UNITED STATES PATENT AND TRADEMARK OFFICE

10/534,956

| Office Action Summary | Application No. 10/534,956 | Applicant(s) KOHL ET AL. | |
| | Examiner YOSEF GEBREYESUS | Art Unit 2811 | |

**FIG. 1**

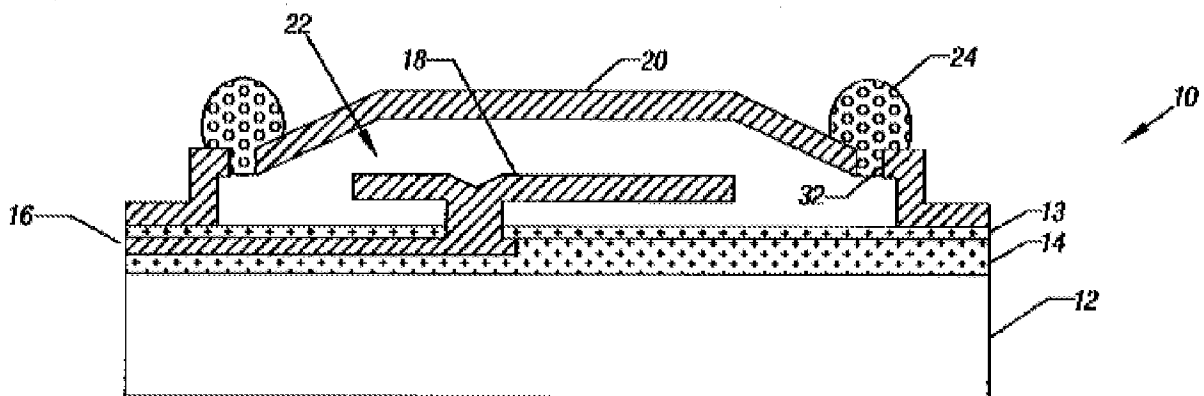
32. Regarding **claim 24**, figures 1-8 (one embodiment) and related text of Heck discloses forming a thermally decomposable sacrificial layer 15 and 25 (paragraph [0015]) on a substrate 12 of a micro electro-mechanical device 18, the sacrificial layer 15 & 25 encapsulating a portion of the micro electro- mechanical device 18 (paragraph

[0013]); said sacrificial layer is patterned (paragraph [0016] and [0017]); forming a contiguous overcoat layer (cover) 20 (the cover is formed without openings 32) (paragraph [0018], [0021]) around the sacrificial layer 15 & 25; and thermally decomposing the sacrificial layer (paragraph [0015]), wherein decomposed molecules of the sacrificial layer permeate through the overcoat layer 20 (paragraph [0021]), and wherein a gas cavity 22 (paragraph [0014]) is formed where the thermally decomposable sacrificial layer 15 & 25 was formed, wherein the contiguous overcoat layer 20 provides an airtight (hermetic seal or vacuum cavity) (paragraph [0014] lines 11-15) and enclosure around the gas cavity 22 (paragraph [0014]).

Heck teaches the sacrificial material is polynorbornene (paragraph [0015]). Heck does explicitly disclose the sacrificial layer is photodefinable and image wise exposing to form a pattern.

However, in the same field of endeavor, figures 1A-1C and related text of Mule discloses using a photodefinable (photosensitive polynorbornene) (paragraph [0055])

material as a sacrificial layer and forming a pattern by using an image wise exposing method (ultra violet radiation) (paragraph [0058]).

Therefore, it would have been obvious to one of ordinary skill in the art at the time the invention was made to form the pattern of Heck's device by using an image wise exposing method as taught by Mule. The ordinary artisan would have been motivated to use such method because it is conventional and known in the art to form patterns by exposing to light.
